# Apple Ridge

# Final Environmental Impact Statement

Town of New Windsor Orange County, New York

October 2019

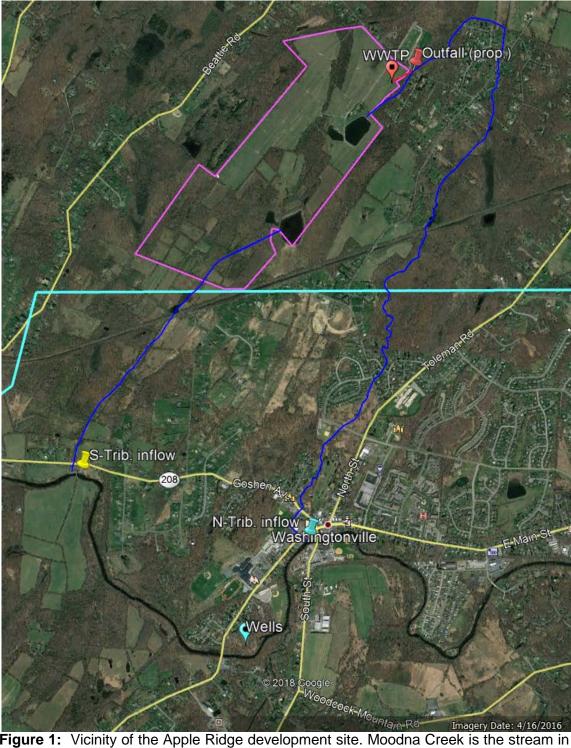
"In Appendix VIII of the Pumping Test Report, the graph of temperature vs. time for Wells 2, 3, and 6 indicated that temperature varied by approximately 7 degrees Celsius. This suggests that an inflow of cold water; and since the test was conducted during the winter, it is possible that inflow from colder surface water (ponds on the property, see Figure 1) was induced during the test or may be induced by long-term pumping."

"Wastewater Engineering Analysis – There are two streams that originate from the proposed Apple Ridge development site. Both streams are intermittent (i.e., are dry some of the time) and are tributaries to Moodna Creek (Figure 1). The designated discharge point of the WWTP effluent is along the northern tributary where little or no flow is available for dilution. It was reported by HydroQual that no flow was observed in this stream after 2 inches of precipitation over a 48-hour period. One NYSDEC definition of an intermittent stream is any stream that periodically goes dry at any point downstream of the proposed point of discharge. Therefore, discharge to this stream would therefore be subject to Intermittent Stream Effluent Limits (ISEL)."

There are two streams that originate from the proposed Apple Ridge development site. Both streams are intermittent (i.e., are dry some of the time) and are tributaries to Moodna Creek (Figure 1). The designated discharge point of the WWTP effluent is along the northern tributary where little or no flow is available for dilution. It was reported by HydroQual that no flow was observed in this stream after 2 inches of precipitation over a 48-hour period. One NYSDEC definition of an intermittent stream is any stream that periodically goes dry at any point downstream of the proposed point of discharge. Therefore, discharge to this stream would therefore be subject to Intermittent Stream Effluent Limits (ISEL).

**Response:** The manual temperature measurements collected by field staff varied by about 7°C (degrees Celsius) due to ambient air conditions; which is not uncommon. The temperature measurements collected from the pressure transducers in the wells showed limited fluctuations which supports the conclusion that the wells are not under the direct influence of surface water which was also supported by the water-level data collected from the piezometers during the test events. In addition, the results for the MPA samples from all of the wells were reported as low-risk for potential groundwater under the direct influence of surface water.

Response: Project Sponsor concurs. No response necessary.
